NAC-UMS  
Docket # 71-9270  
TAC # L22452

**REQUEST FOR ADDITIONAL INFORMATION**

**NAC UNIVERSAL TRANSPORT SYSTEM (NAC-UMS®)**

**SAR SUBMITTAL – REVISION UMST-01D**

Figure RAI 2.9-1 Dynamic Load Factor for Single Degree of Freedom System – Triangular Pulse Shape, No Damping

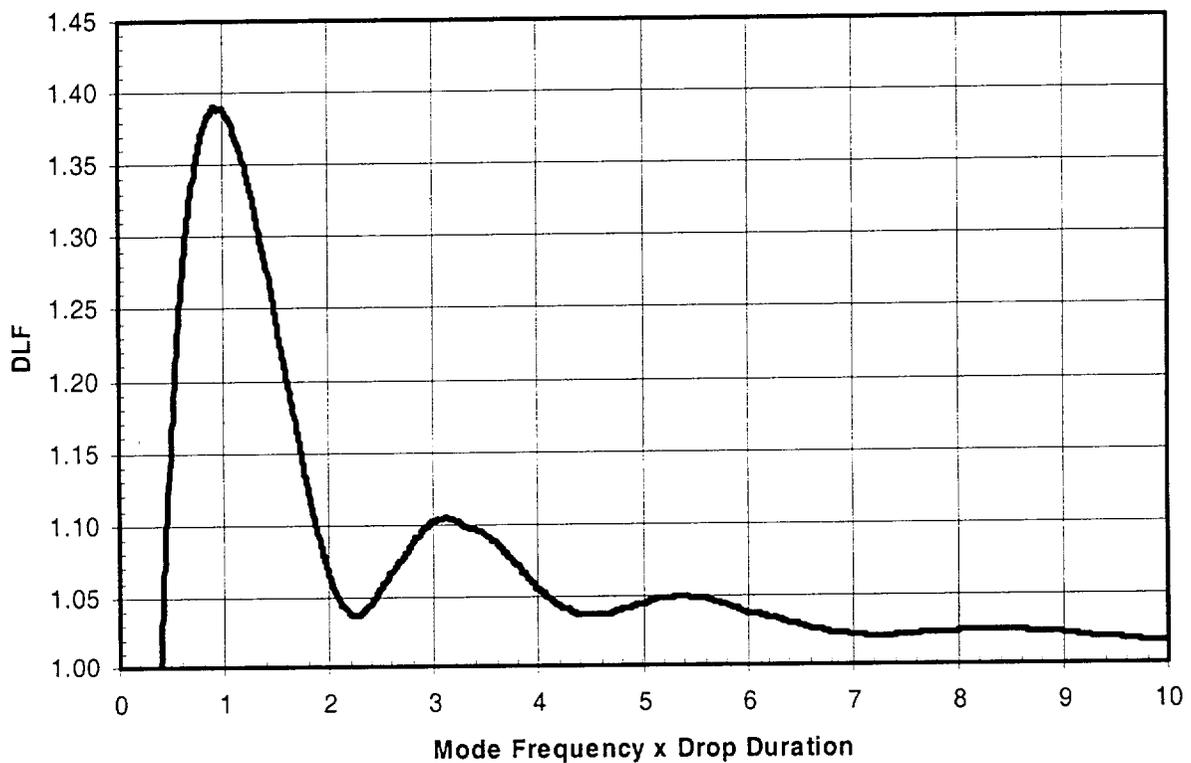
2-9 With respect to SAR Figures 2.6.7.5-5, -6, and -7, provide an evaluation of effects of vibratory response components on the maximum decelerations as presented in Table 2.6.7.5-6.

The staff recognizes the need for low-pass filtering both the test and calculated results for removing spurious, high frequency, response components which are inherent to the numerical modeling but non-consequential for practical cask design consideration. The staff notes that rigid body response components are generally considered for benchmarking a cask/impact limiter finite element analysis model. However, to determine peak cask decelerations by either testing or analysis, contributions from vibratory response components, which would be associated with predominant cask vibration modes of interest, should also be properly considered. Complete and accurate information should be provided, per Section 71.1(a), for evaluating the package free-drop performance under Sections 71.71(c)(7) and 71.73(c)(1).

To determine the predominant cask vibration modes of interest, a modal analysis of the basket support disks was performed using the ANSYS program that calculates the frequencies for the side drop for the BWR and PWR baskets for the end drops and side drops. To determine the dynamic load factor (DLF), the side drop and end drop are treated as single degree of freedom systems with triangular pulse shape and no damping. Figure RAI 2.9-1 plots the DLF verses the mode frequency times the drop duration for a triangular pulse shape. The following table summarizes the DLF for each orientation.

In all cases, the factored accelerations that include the effects of the cask vibratory response are less than the design accelerations employed in the evaluation of the UMS<sup>®</sup> cask.

Figure RAI 2.11-1 Comparison of Quarter-Scale Model Side Drop (LS-DYNA and Drop Test) Results (Upper Accelerometer)

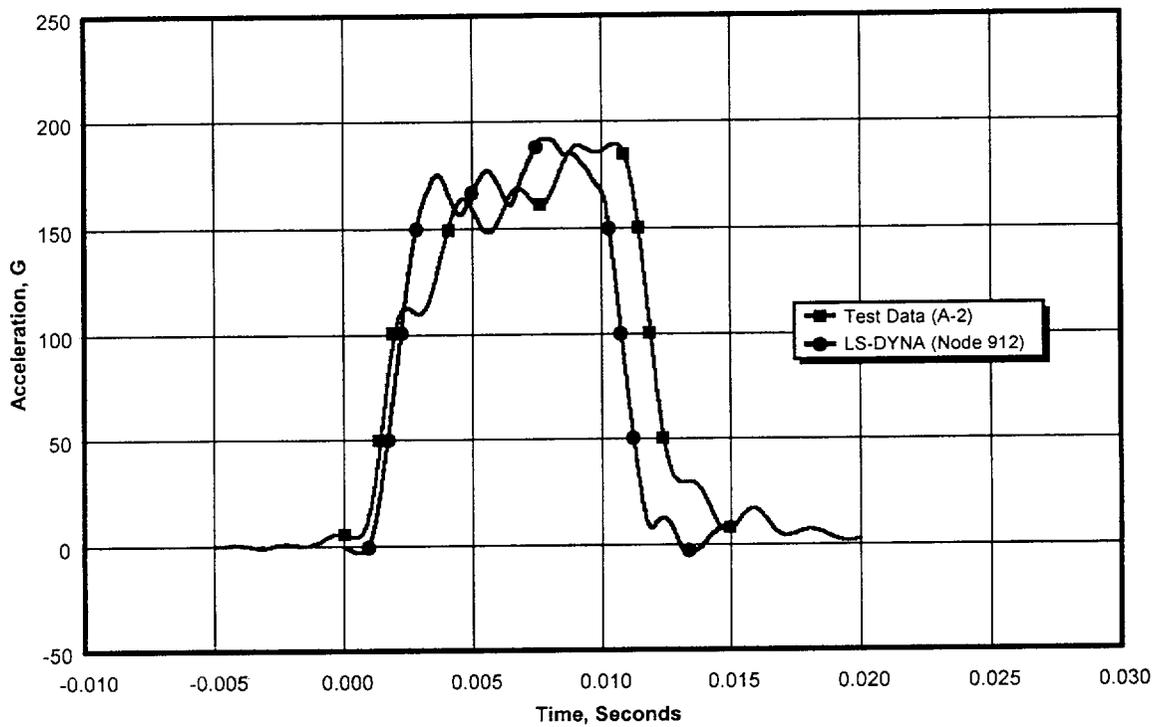
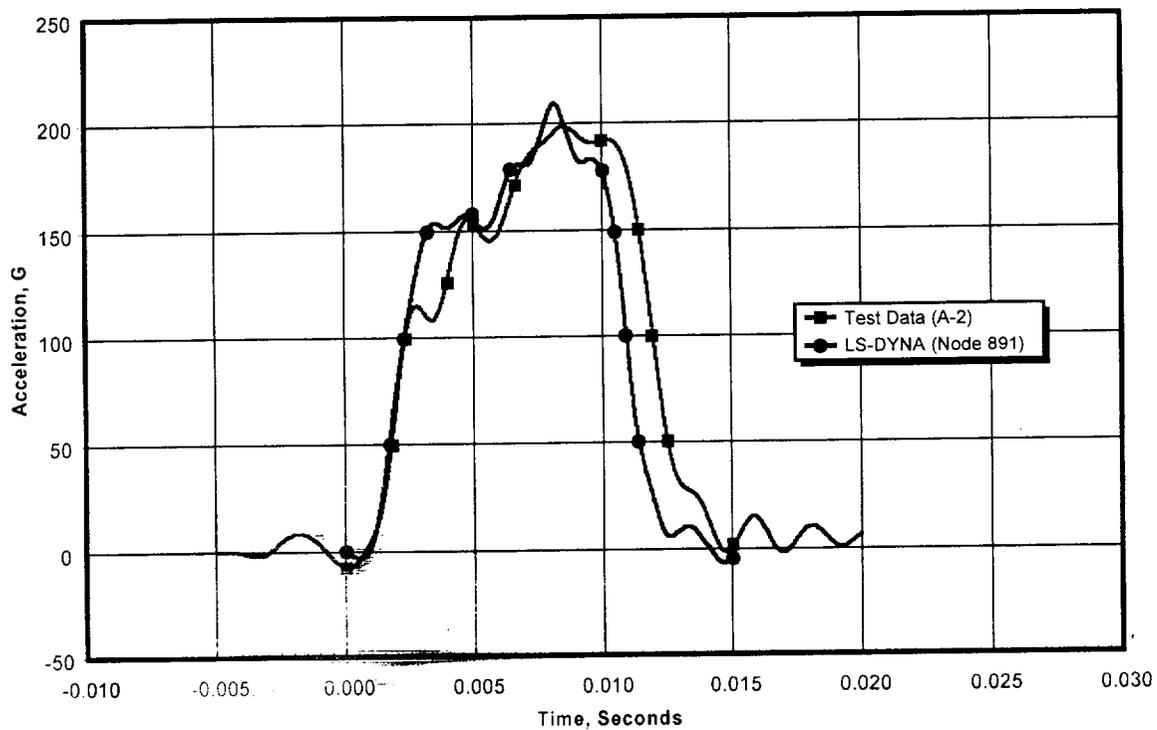
- 2-11 With respect to Figures 2.10.3-8 and -9, explain why the LS-DYNA calculated and low-pass filtered deceleration time histories do not contain similar vibratory response components to those recorded for the side drop test.

The staff notes that both the analysis and test raw data were reduced with the same low-pass filtering parameters. As such, the analysis results are expected to display also the vibratory response components superimposed on the rigid body cask responses. Complete and accurate information should be provided, per Section 71.1(a), for evaluating the package free-drop performance under Sections 71.71(c)(7) and 71.73(c)(1).

The vibratory response noted in the test data is a direct result of the sampling rate at which the data was recorded. The sampling rate used by Sandia National Laboratories during the quarter-scale model side drop test was approximately 250,000 Hz, which results in a data point being recorded every 1/250,000 seconds and reduces the effectiveness of the Butterworth filter. Typical LS-DYNA analyses are performed with sampling rates from 50,000 to 100,000 Hz. For the purposes of this evaluation, the data rate in LS-DYNA was increased to 250,000 Hz. Figures RAI 2.11-1 and RAI 2.11-2 provide the comparison of the analysis and test data with the 250,000 Hz sampling rate. Both curves are filtered at 450 Hz. Figures 2.10.3-8 and -9 have been updated with the new results. The updated curves show similar frequency content in terms of the oscillatory behavior.
